NEW MEXICO
ENVIRONMENT DEPARTMENT

January 18, 2008

**RE: NOTICE OF DISAPPROVAL
LOS ALAMOS AND PUEBLO CANYONS GROUNDWATER MONITORING
WELL NETWORK EVALUATION AND RECOMMENDATIONS
LOS ALAMOS NATIONAL LABORATORY
EPA ID #NM0890010515
HWB-LANL-07-039**

Figure H-1 Structure contour map for the base of the Guaje Pumice Bed in the vicinity of Sandia Canyon. Arrows show inferred direction of movement for water diverted along this contact.

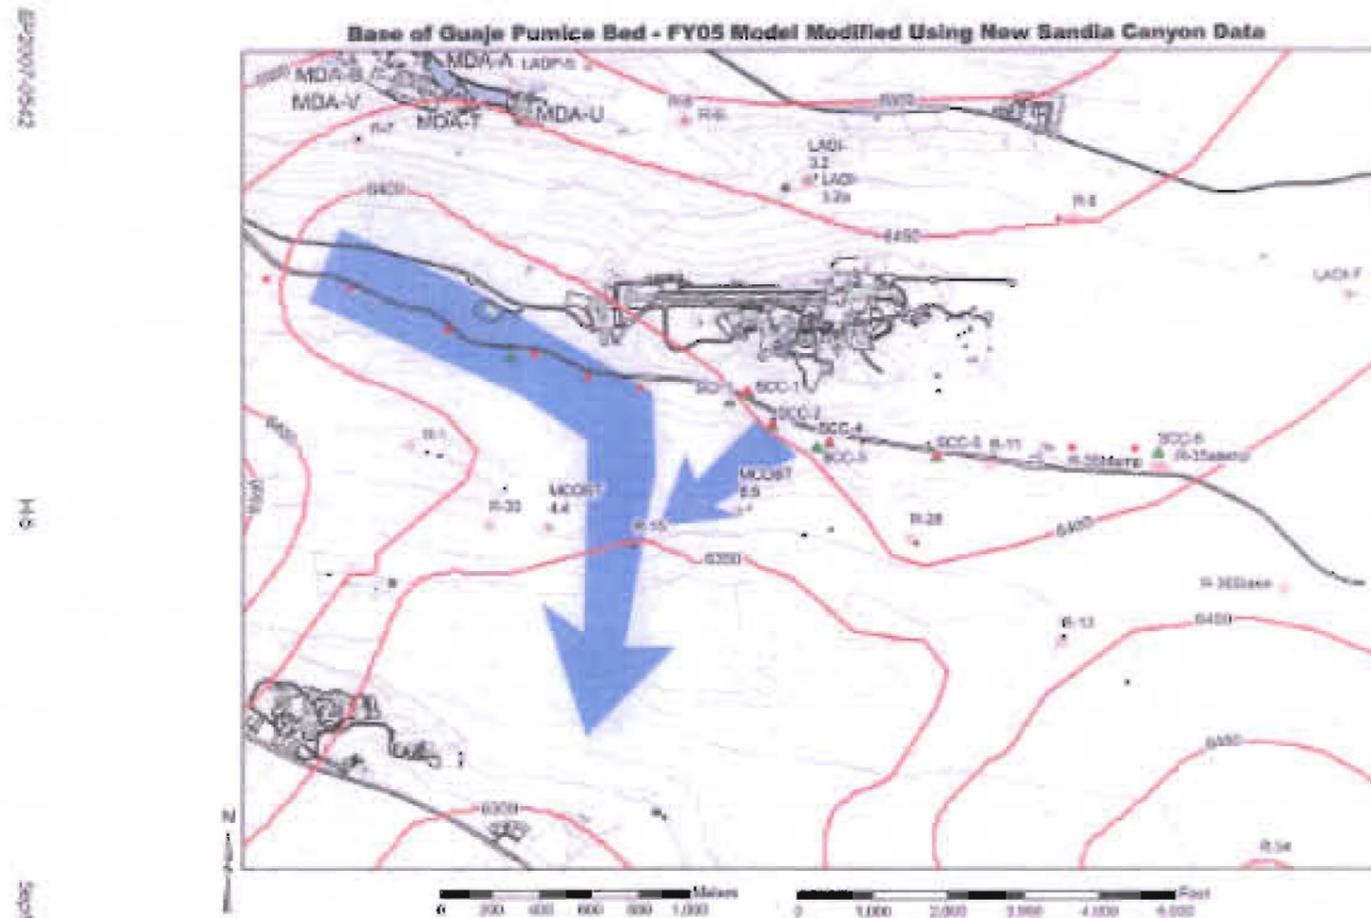
NMED is concerned about lateral transport of contaminants via perched-intermediate groundwater beneath Los Alamos Canyon (including Delta Prime Canyon), especially the zone intercepted by wells LADP-3, R-6i, LAO-3.2a and LAOI-3.2 (details illustrated in Figure 2.0-1 of the Report). This zone of perched-intermediate groundwater (with a thickness from 9 to 31 feet) appears to be present in the Guaje Pumice Bed that overlies relatively impermeable silt-rich deposits of the Puye Formation. According to the Permittees' findings (LANL 2007, *Fate and Transport Modeling Report for Chromium Contamination from Sandia Canyon*), the contact between the Guaje Pumice Bed and the Puye Formation extends west to Pajarito Canyon and generally dips southwestward in the area surrounded by LADP-3, R-6i, LAO-3.2a and LAOI-3.2. Perched groundwater in this more permeable unit (Guaje Pumice Bed) will most likely move along the geologic contact until percolation to the regional aquifer occurs. Therefore, it is reasonable to project that the perched-intermediate groundwater present in this zone may primarily move southwestward, rather than along the Los Alamos Canyon surface water drainage from west to east. The Permittees have recognized a similar potential lateral movement for perched-intermediate groundwater present beneath Sandia Canyon (see the attached map).

To address the potential movement of contaminated perched-intermediate groundwater toward the southwest, the Permittees must modify the current conceptual site model to account for lateral movement of perched-intermediate groundwater beneath Los Alamos Canyon. The modified conceptual site model must address the connectivity of the perched-intermediate groundwater identified beneath Los Alamos and Sandia Canyons. If there are data gaps limiting development of the necessary conceptual site model to address potential southwestward movement of perched-intermediate groundwater, the Permittees must propose to advance borings at appropriate locations in the central and east parts of Technical Area (TA) 53 to investigate whether perched-intermediate groundwater is present beneath the mesa between Los Alamos and Sandia Canyons. If perched-intermediate groundwater is observed, monitoring wells must be installed to evaluate the fate and transport of contaminants potentially originating from the zone intercepted by LADP-3, R-6i, LAO-3.2a, and LAOI-3.2, and any other perched groundwater that is encountered.
